<b>TO</b>	Interstate Network
<b>FROM</b>	Corporate Services & Safety, General Manager Technical Standards
<b>DATE</b>	22 August 2018
<b>SUBJECT</b>	Track and Civil Code of Practice – Section 1 Rail – Technical Note ETD-01-02 for 60kg/m tangent rail profile.
<b>Amendment</b>	First Issue

Figure 1. Detail of Head Profile 60 Kg/m Rail (Not to Scale)

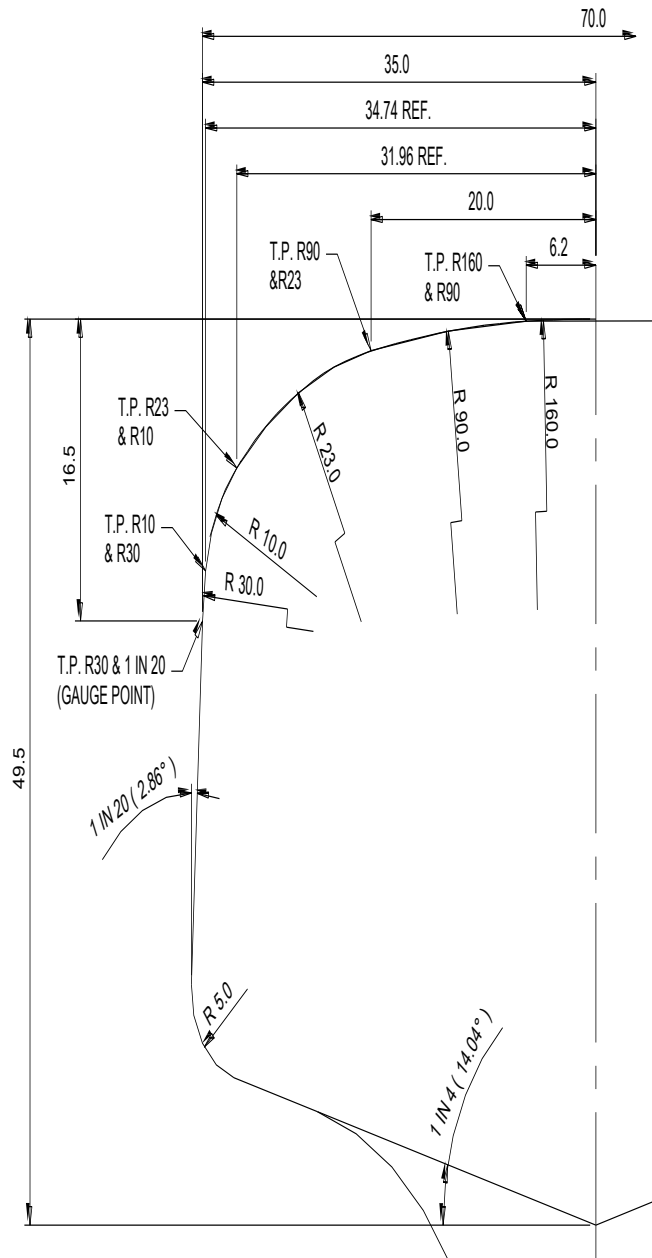
b. Track with curvature above R800m (particularly tangents) should use 60kg/m that complies with all aspects of AS 1085.1 or equivalent standard, except for the modified head profile shape as specified below in Figure 1. Marking of this modified 60kg rail profile shall comply to AS1085.1, however with the removal of the rolled in "1085.1" portion of the branding (AS to remain) and the addition of brand modification letter "T", to indicate Tangent.
